From: Pederson Ronda M (AREVA NP INC) [Ronda.Pederson@areva.com]
Sent: Thursday, September 17, 2009 4:58 PM
To: Tesfaye, Getachew
Cc: BENNETT Kathy A (OFR) (AREVA NP INC); DELANO Karen V (AREVA NP INC); VAN NOY Mark (EXT); RYAN Tom (AREVA NP INC)
Subject: Response to U.S. EPR Design Certification Application RAI No. 215, FSAR Ch 3, Supplement 2
Attachments: RAI 215 Supplement 2 Response US EPR DC.pdf

Response to

Request for Additional Information No. 215, Supplement 2

U.S. EPR Standard Design Certification

Figure 3.7.3-26-1—Subsystems with Straight Run Modeled as (a) Distributed Mass and (b) Lumped Mass

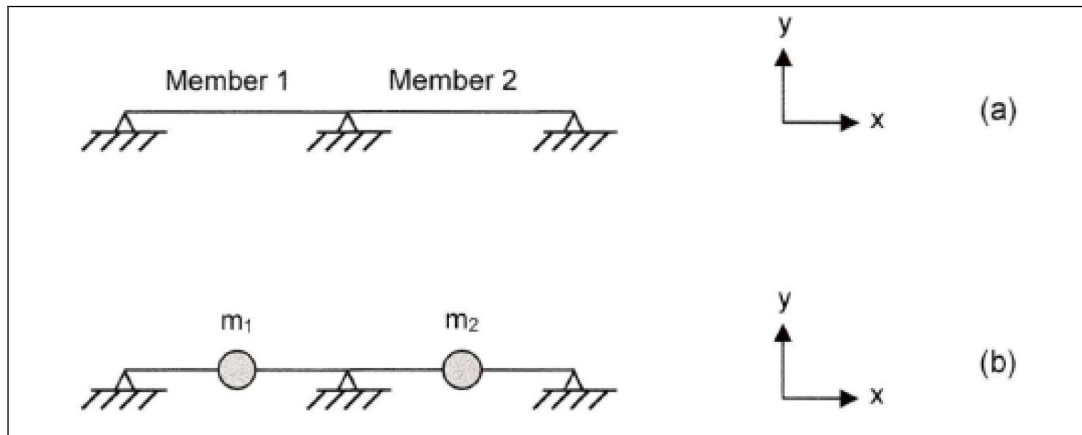
The response to Question 03.07.03-6 requires additional information. Linear, frame-type subsystems, such as piping, HVAC, cable tray, and conduit are likely to have horizontal bends, changes in elevation and, in the case of piping and conduit, contain branch connections. These types of sub-systems are usually modeled seismically from anchor-point to anchor-point, which normally do not lie in straight line. The applicant is requested to provide the criteria and procedures used in neglecting some of the degrees of freedom, including the rotational degrees of freedom, in seismic analysis and provide examples of applications to various types of subsystems.

- Figure 3.7.3-26-1(a) and Figure 3.7.3-26-1(b) show straight runs of subsystem which are modeled as simply supported with distributed mass and lumped mass, respectively. In the lumped-mass case, local rotational degrees-of-freedom can be neglected, provided that no external forces are applied in the local rotational degrees-of-freedom. Example 9.10 by Chopra in "Dynamics of Structures," 3rd Edition, Pearson Prentice Hall, Upper Saddle River, New Jersey, 2007 provides a calculation of such a lumped-mass model.
- Rotational responses of the following models may not be negligible when subjected to external forces and, thus, all six degrees-of-freedom are considered at all nodes:
 - Subsystems with changes in elevation (see Figure 3.7.3-26-2(a) and Figure 3.7.3-26-2(b)).
 - Subsystems with an intersection between horizontal members and vertical member (see Figure 3.7.3-26-3).
